REVISED RESPONSE TO REQUEST FOR ADDITIONAL INFORMATION

APR1400 Design Certification

Docket No. 52-046

RAI No.: 222-8203
SRP Section: 11.05 – Process and Effluent Radiological Monitoring Instrumentation and Sampling Systems
Application Section: 11.5
Date of RAI Issued: 09/23/2015

Figure 11.5-3C Monitor Assembly for Main Steam Line Effluent + N-16 Detectors

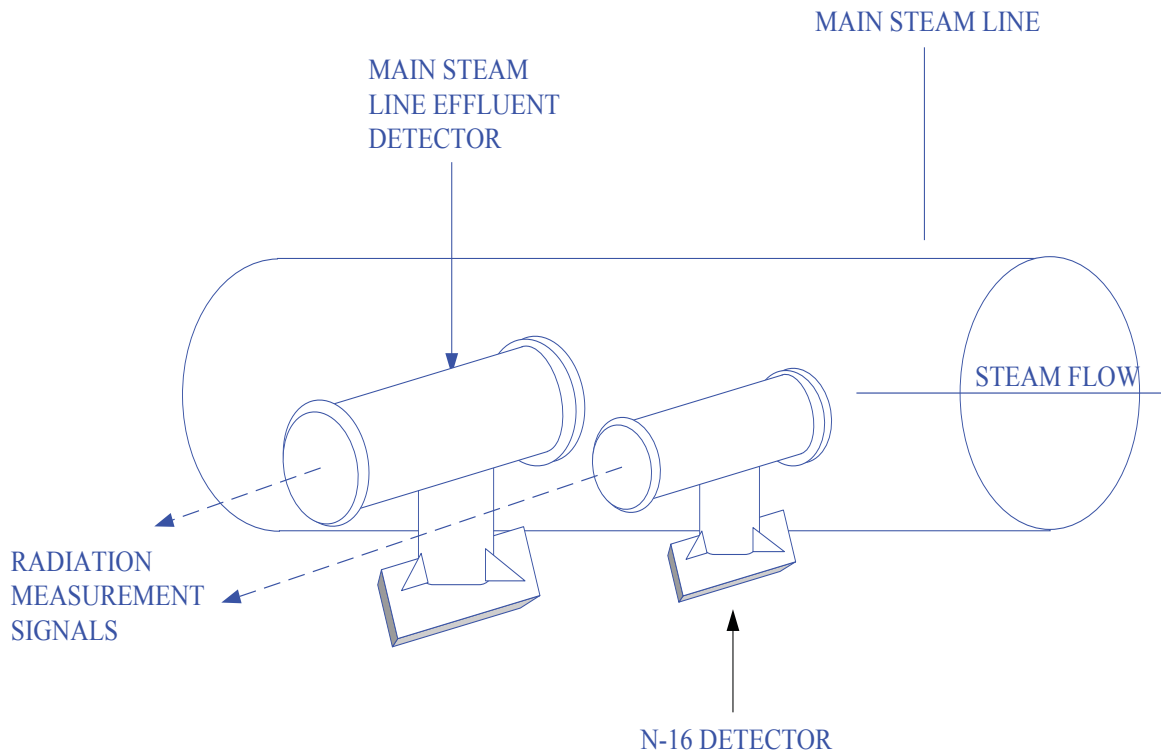
Because the reactor coolant system (RCS) is a safety-related system, steam generator (SG) tube integrity is a safety-related issue. 10 CFR 52.47(b)(1) requires that a DC application contain the proposed ITAAC that are necessary and sufficient to provide reasonable assurance that, if the inspections, tests, and analyses are performed and the acceptance criteria met, that a plant that incorporates the design certification is built and will operate in accordance with the design certification and the provisions of the Atomic Energy Act, and NRC regulations. The applicant has not provided adequate Tier 1 ITAAC information to verify the compliance with the design criteria.

The ITAAC should address the sensitivity, response time, and alarm limit for the SG Tube leakage detection instrumentation. The staff requests the applicant to provide ITAAC for this system in the DCD Tier 1.

Please address this item and provide a markup for the proposed DCD changes.

The APR1400 design provides for the monitoring of radioactive releases from the MSSV and MSADV during SGTR using the Main Steam Line Effluent Detectors, which is an additional function of RE-217 ~ RE-220.

This is required by RG 1.97 Rev.3 and the RMS purchase specifications require the supplier comply with this requirement. Please refer to DCD Tier 2, Subsection 11.5.2.2.5.m and Figure 11.5-3C.

DCD Tier 2 Subsection 11.5.2.2.5.m, Figures 11.5-2K, 11.5-2L, 11.5-2M, 11.5-2BB and Appendix 11B will be updated. Figure 11.5-3C will be added.

One monitor on each of the four main steam lines is provided in the main steam line support structure. The monitors are placed as close as possible to the pipe as shown in Figure 11.5-3C, upstream of the main steam atmospheric dump valves and main steam safety valves.

1. The main steam line (MSL) effluent monitor detects the radioactive effluent discharge through MSSV's, MSADV and AUX feedwater pump exhaust. This detector performs the function required by NRC RG 1.97.
2. The N-16 detector senses the SG tube leak.
3. Depending on the supplier, the two detectors (MSL and N-16) is assembled as one unit or the two are mounted as two separate but adjacent unit as shown above.
